UNITED STATES PATENT AND TRADEMARK OFFICE

| Office Action Summary | Application No. 10/543,026 | Applicant(s) LEGRAND, EMMANUEL | |
| | Examiner GHASSEM ALIE | Art Unit 3724 | |

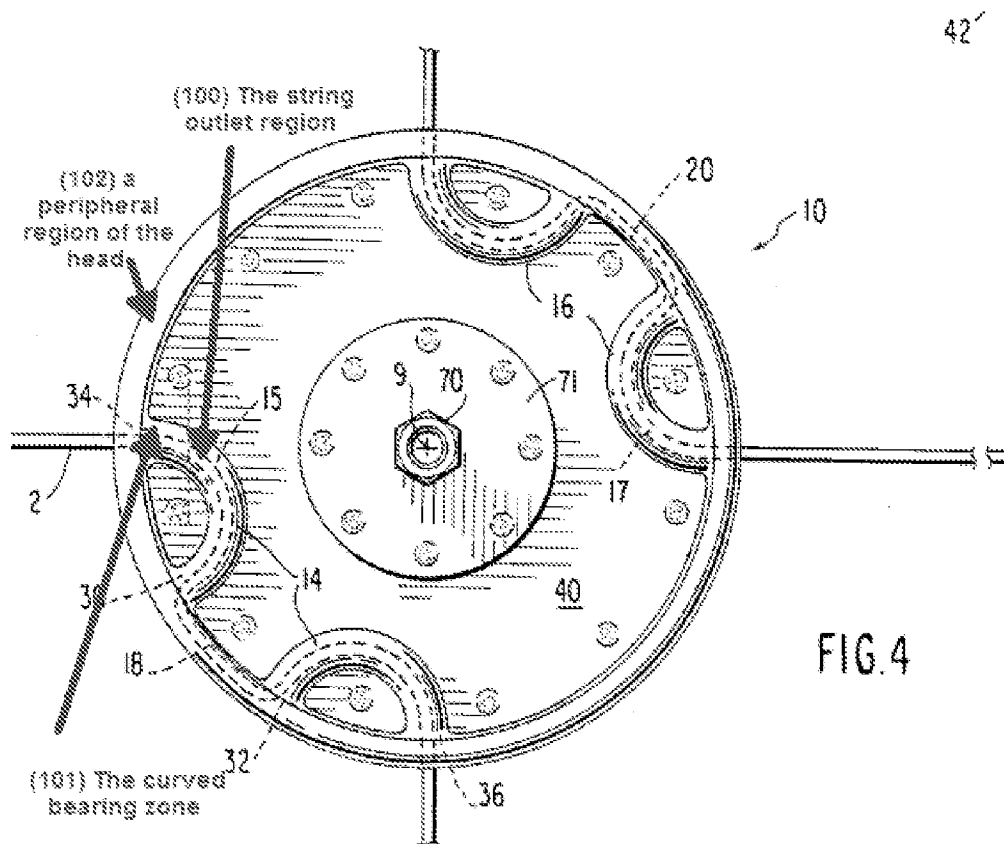
6. Claims 1-5, 9-12, 14 and 24 are rejected under 35 U.S.C. 102(b) as being anticipated by Rouse (4,756,146). Regarding claim 1, Rouse teaches a cutting head 10 including a passageway 14 for a cutting string 2 extending along an axis that is offset from an axis of rotation 9 of the cutting head and at least one curved bearing zone 101 extending between a string outlet region 100 of the passageway and a peripheral region 102 of the head. It should be noted that the string outlet region could be defined by the mid-section of the passage, and the curved bearing region could be considered as the region between the string outlet region to the periphery region of the head as show in Fig. 1 below. It should also be noted that the at least portion of the string, e.g. the bottom portion of the string in the passageway, is extended along an axis which is off set from the rotational axis 9 of the cutting head. Rouse also teaches that a surface of the curved bearing zone presents a recessed profile 46 which is suited to the cross-section of the cutting string 2, in order to guide the cutting string in the recess when the string flexes in a direction opposite to the rotation of the head to rest against the curved bearing zone.

Regarding claim 3, Rouse teaches everything noted above including that the curved bearing zone is situated on a widening of the string passageway in the vicinity of a string outlet. It should be noted that the curved bearing zone is located or situated also in the widening region of the passageway. See Fig. 4 above.

Applicant's argument that that Rouse does not teach "at least one curved bearing zone extending between a string outlet region of said passageway and a peripheral region of the head" is not persuasive. As stated above, Rouse teaches at least one curved bearing zone 101 extending between a string outlet region 100 of the

passageway and a peripheral region 102 of the head. It should be noted that the string outlet region could be defined by the mid-section of the passage, and the curved bearing region could be considered as the region between the string outlet region to the periphery region of the head as show in Fig. 1 above.
